Economic Commission for Europe
Inland Transport Committee
World Forum for Harmonization of Vehicle Regulations
Working Party on Lighting and Light-Signalling
Eighty-second session

Geneva, 22-25 October 2019

Report of the Working Party on Lighting and Light-Signalling on its eighty-second session
Contents

Figure A3-X

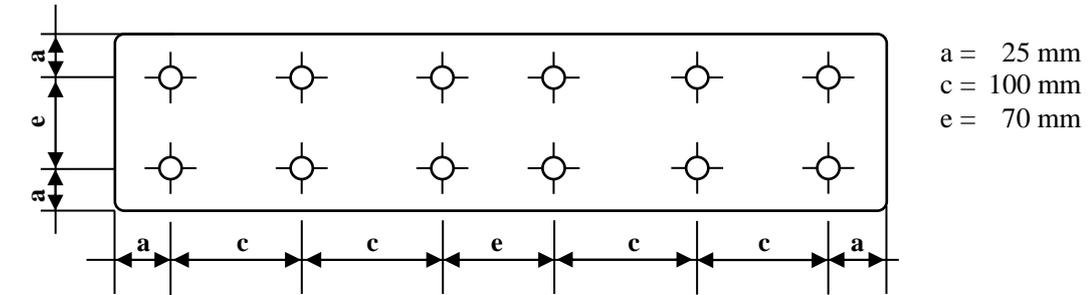
Annex 3, paragraph 3.2., figure A3-X, amend to read:

“3.2. Category 1b - wide plate (520 x 120 mm)

Measuring points for plate size 520 x 120 mm
